RE: Amendment to the Plan Development Final Plan – Signage Hardship

Stratus is currently working with the property owner Encompass Health at the location 1201 American Way, Libertyville, IL 60048. We are requesting an amendment to the plan development final plan to allow for 3 additional signs (1 wall sign and 2 directional signs). As a rehabilitation institute with multiple ambulance visits per week, building identification and wayfinding signage are extremely important to the welfare of patients.

C78512  
Libertyville, IL  
1201 American Way  
3/20/2023

**E01** Face-Lit Letterset with Custom FCO Tagline

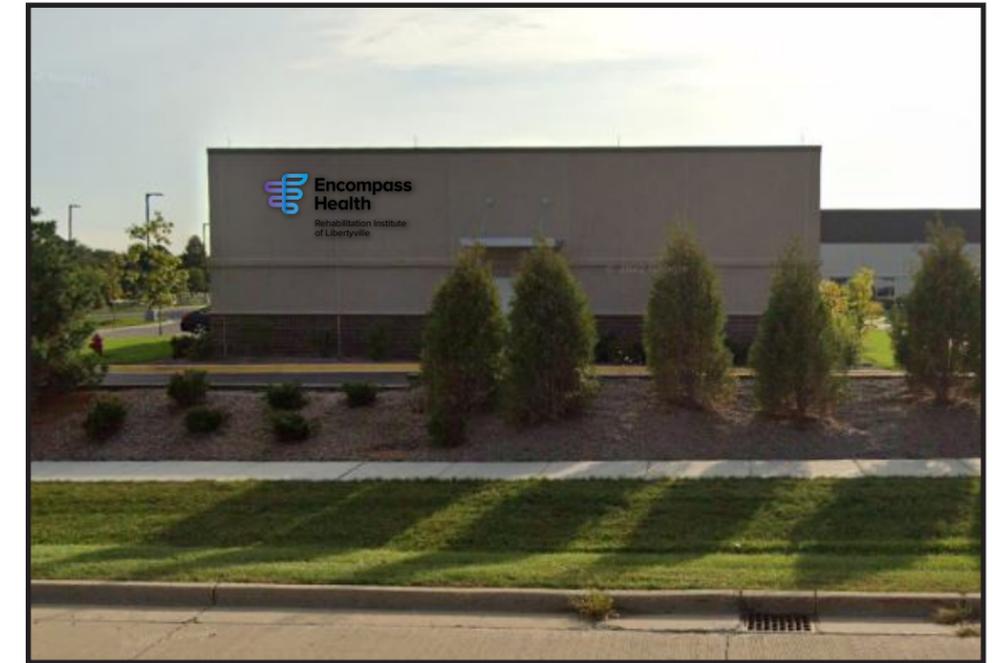
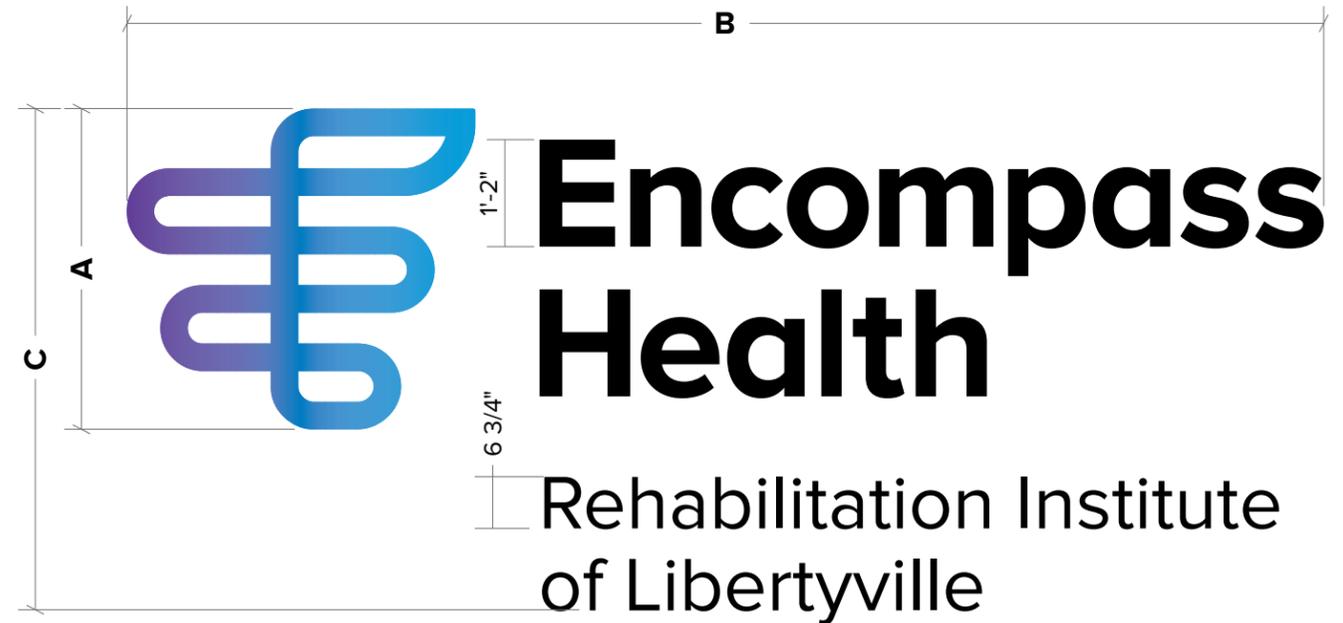
Currently, the side of the building which faces a prominent thoroughfare (IL Route 45/Lake St.) is lacking any identifying signage. We are proposing the addition of a wall sign E01 at the northwest corner of the building to aid in identification. We are also proposing the addition of two directional signs E02 and E03. The intention and specific sizing of these directional signs is to provide ambulances entering either the north or the west driveways with proper wayfinding to guide them towards the patient transfer entry which is dedicated solely to ambulance drop-offs. This is important as the main entrance which is used for general admissions, is separate from the patient transfer entrance for ambulances.

Install new standard illuminated letterset with custom FCO tagline as shown.

AFTER - Install centered horizontally between seams & vertically in available space

**E02 Non-Illuminated S/F Directional - SOUTH ENTRANCE - (Qty 1)**

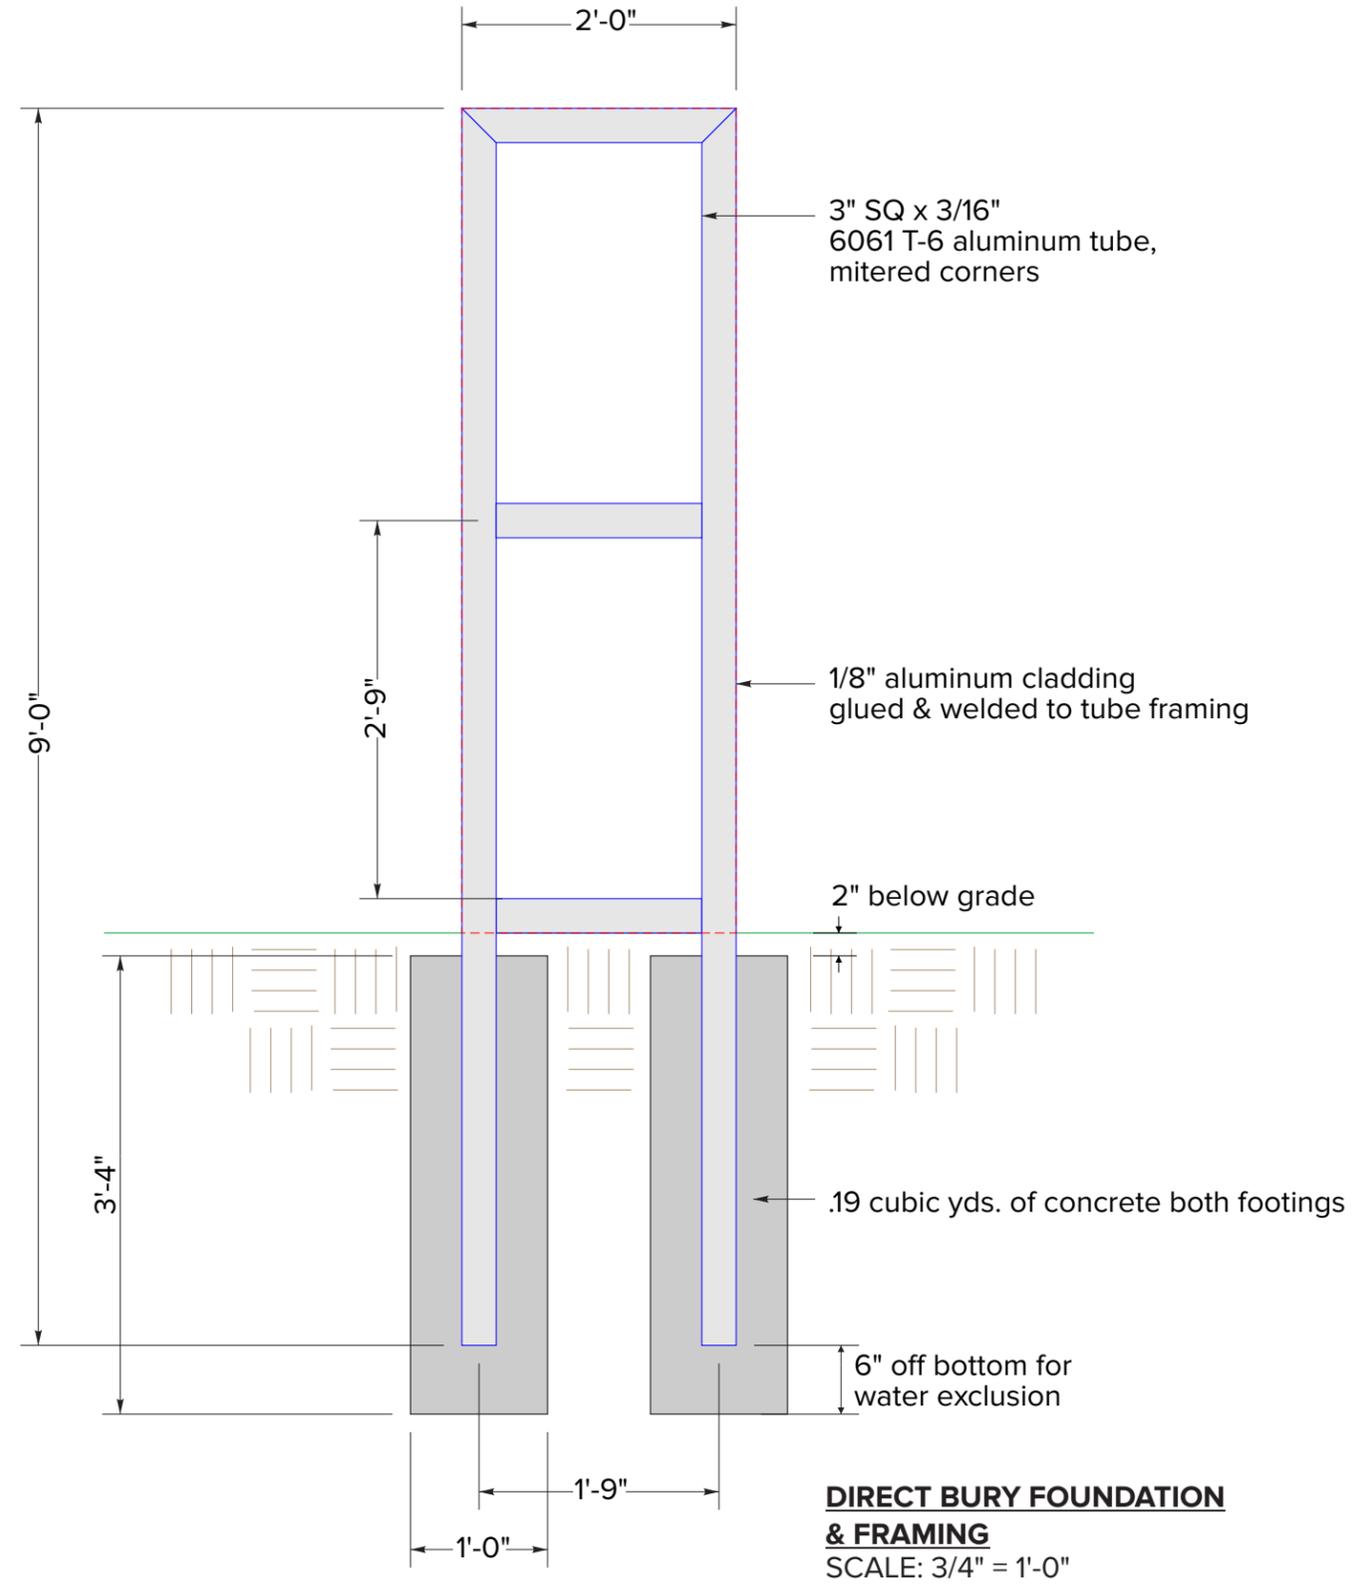
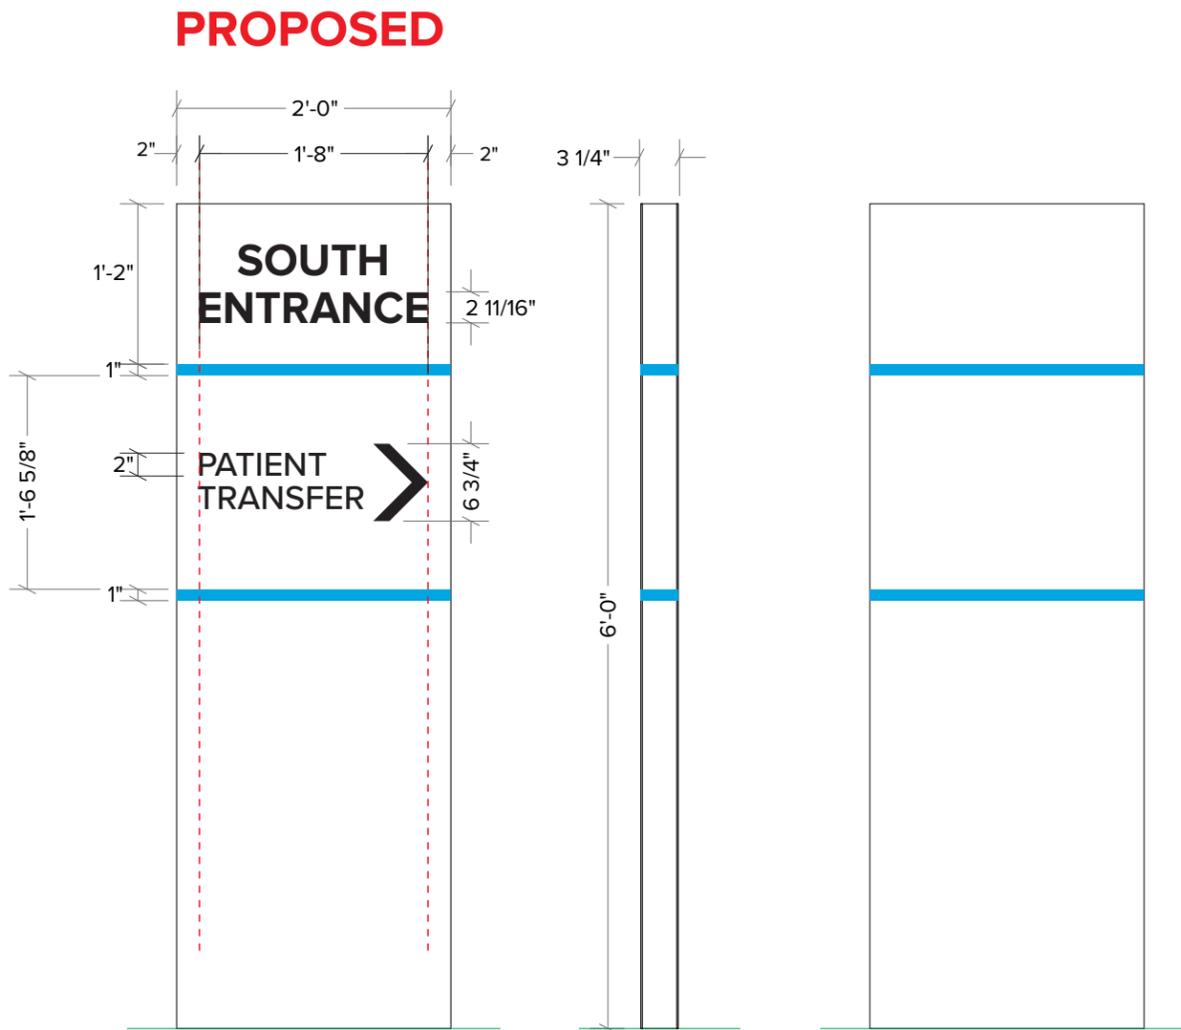
**NOTE:** 5'-0" setback from property line.

**E02.1 Custom Non-Illuminated S/F Directional - SOUTH ENTRANCE - (Qty 1)**

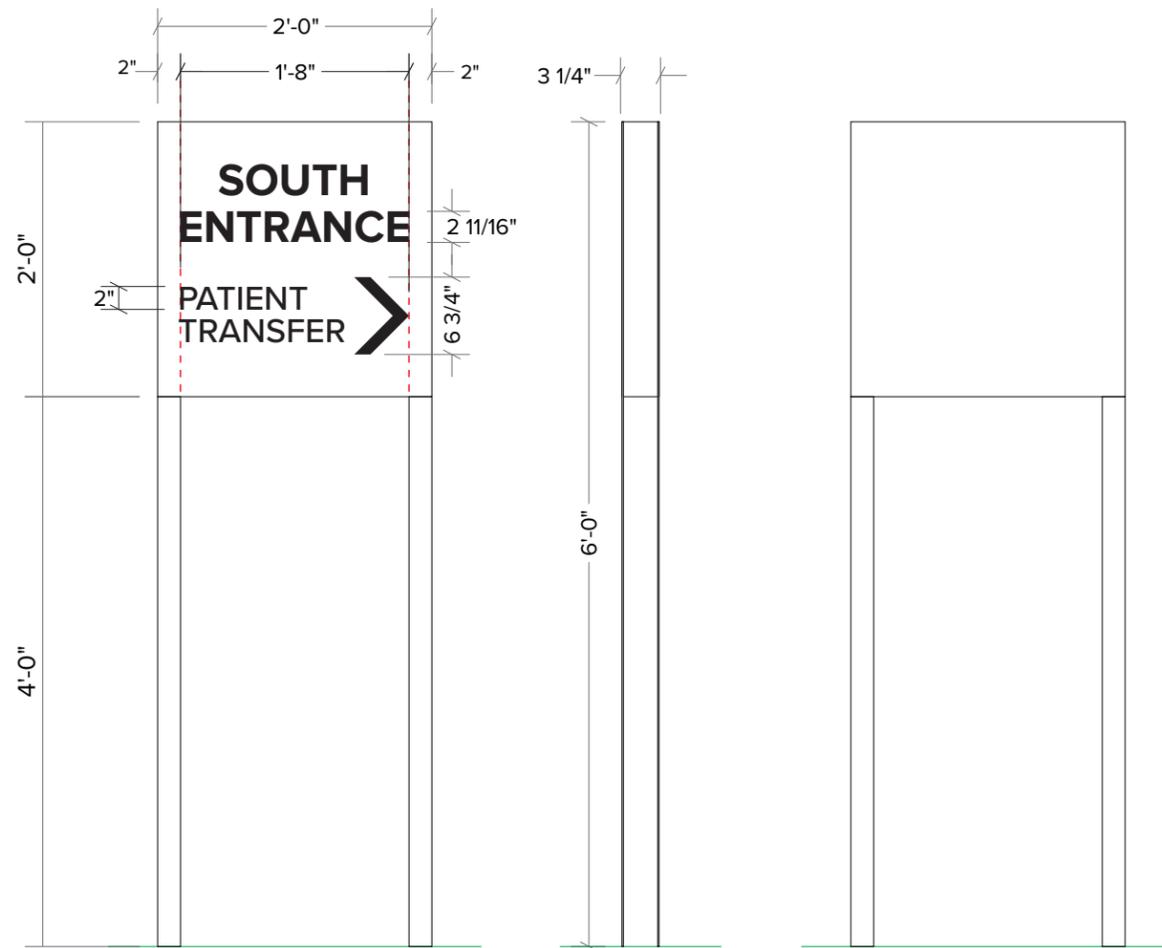
**PROPOSED ALTERNATE (Smaller Version) TO E02.**

**E03 Non-Illuminated S/F Directional - NORTH ENTRANCE - (Qty 1)**

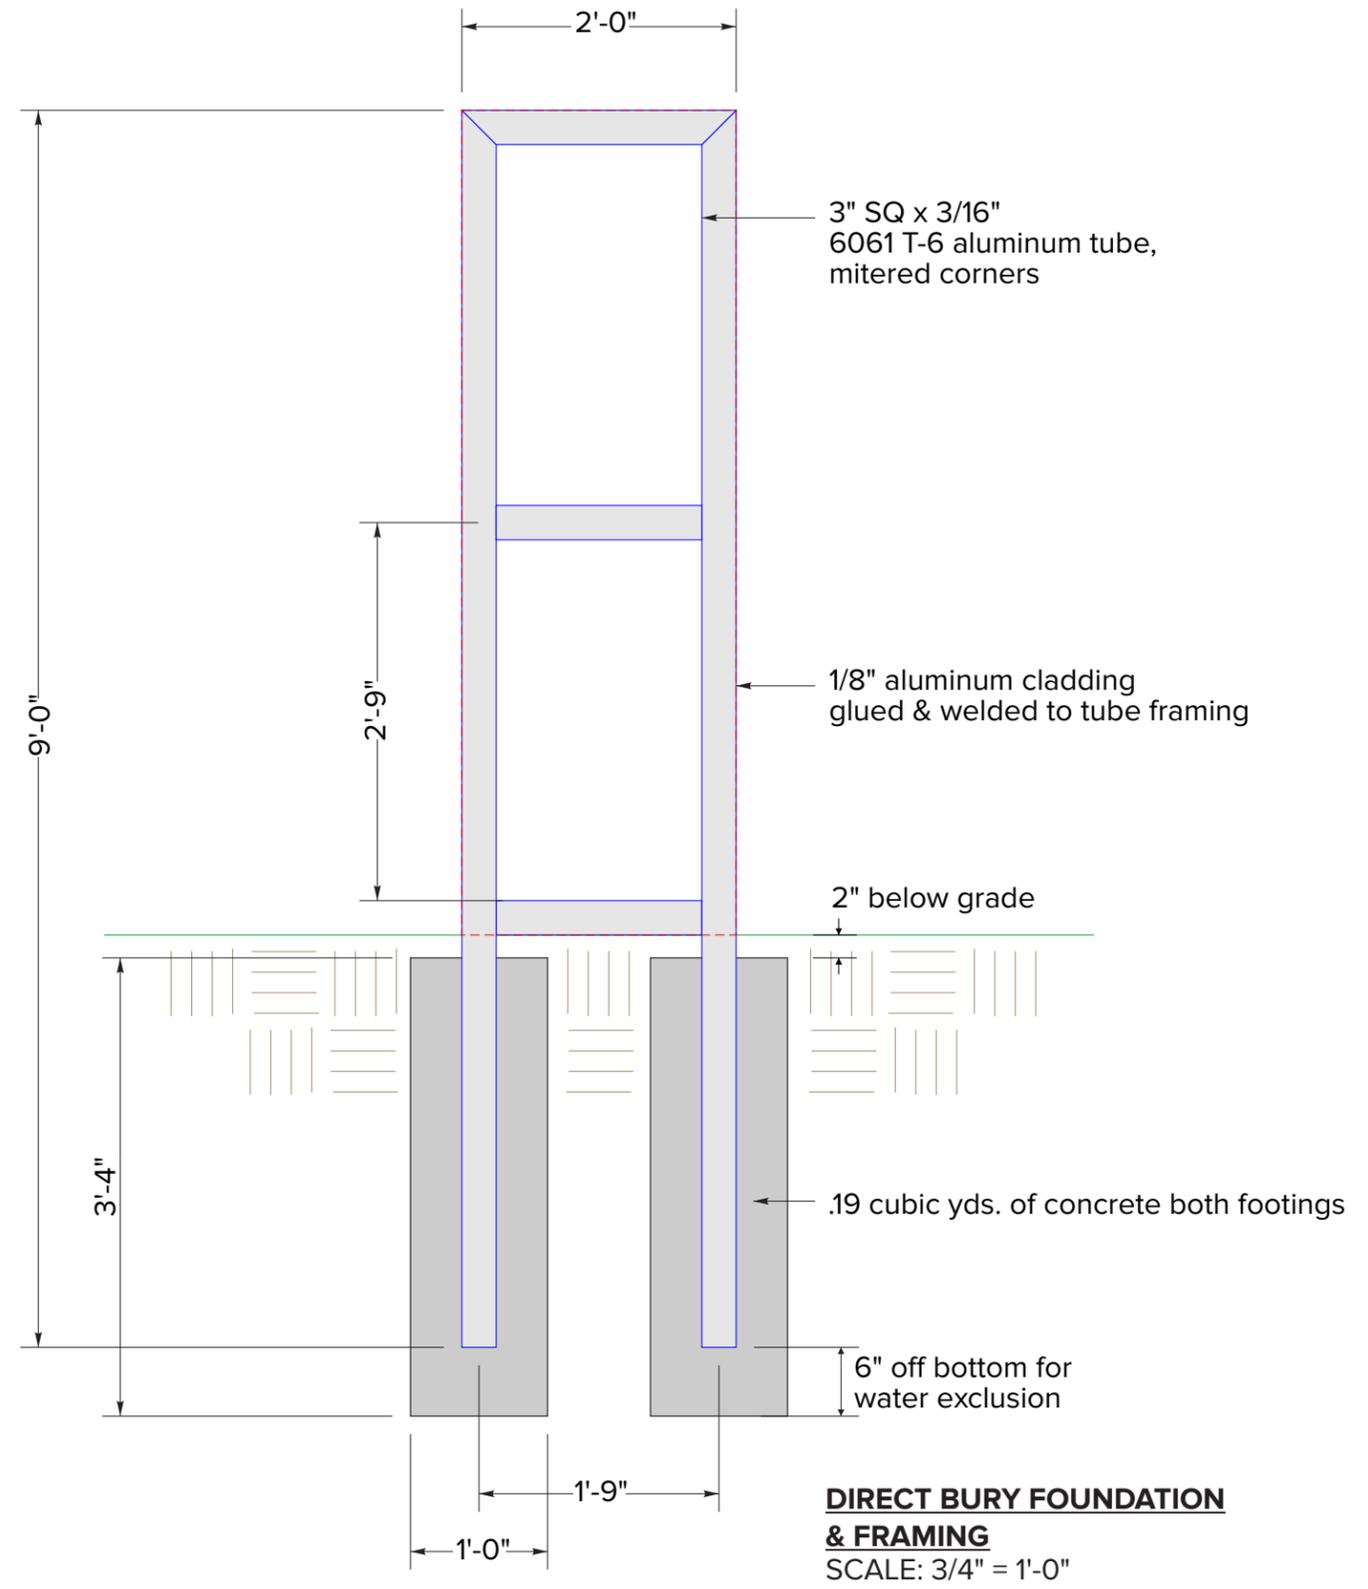
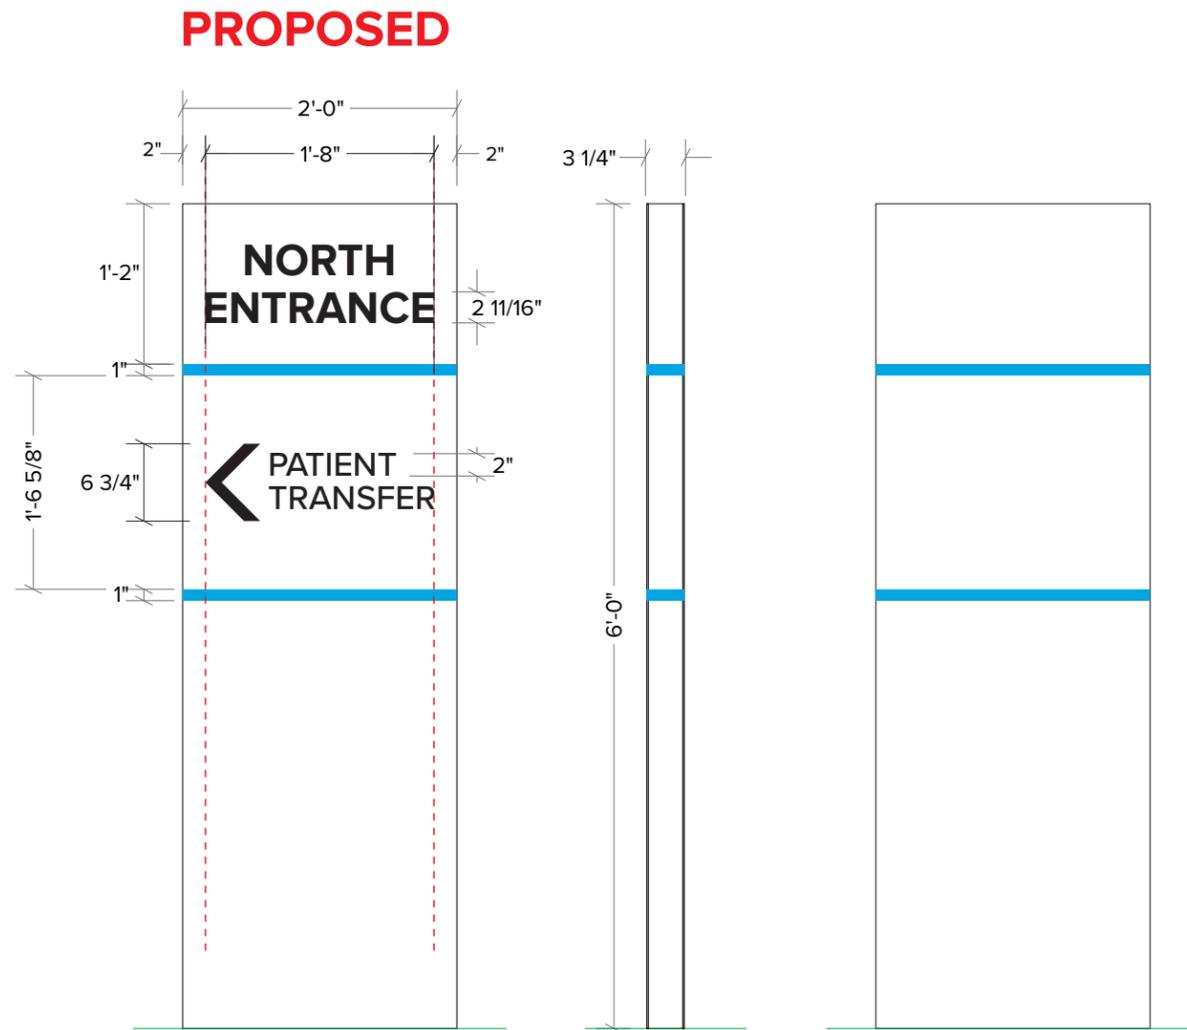
**NOTE:** 5'-0" setback from property line.

**E03.1 Custom Non-Illuminated S/F Directional - SOUTH ENTRANCE - (Qty 1)**

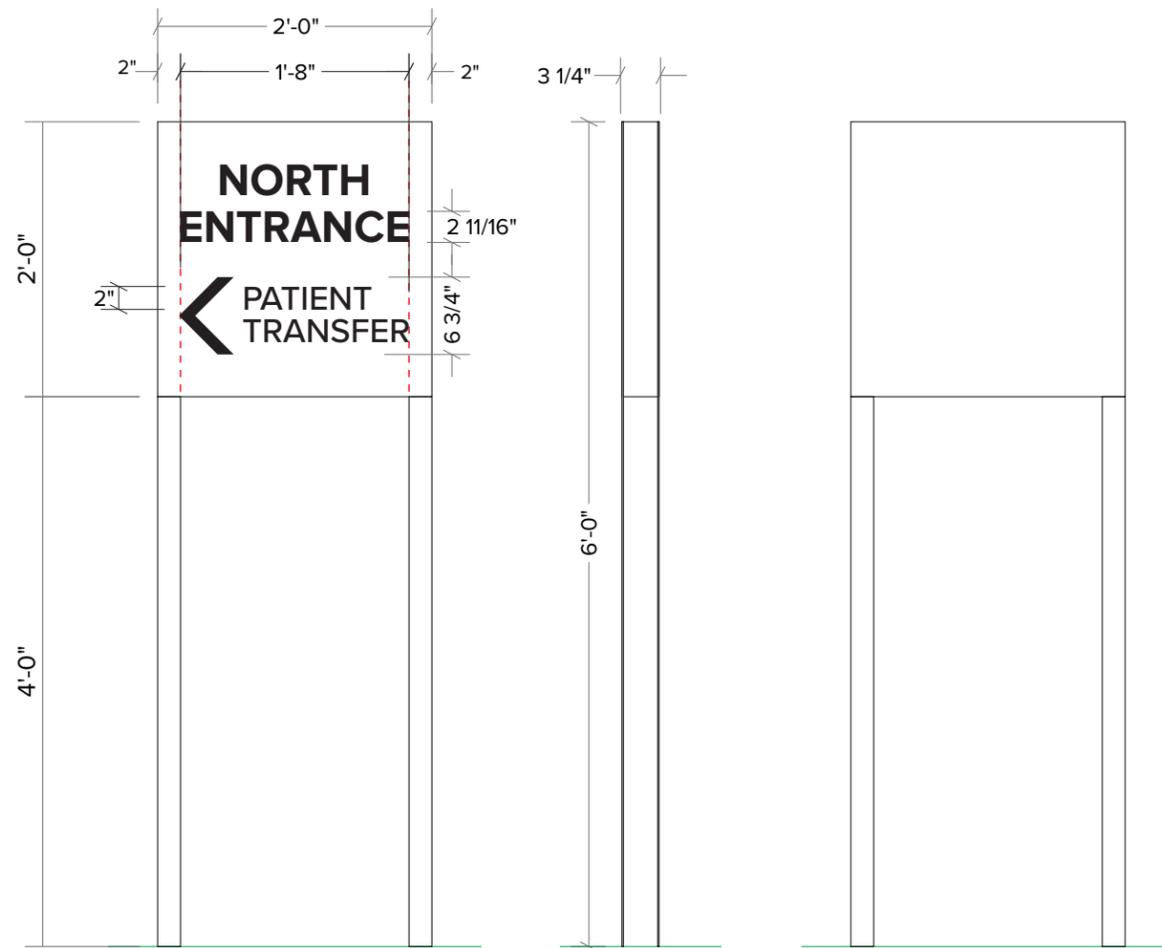
**PROPOSED ALTERNATE (Smaller Version) TO E03.**
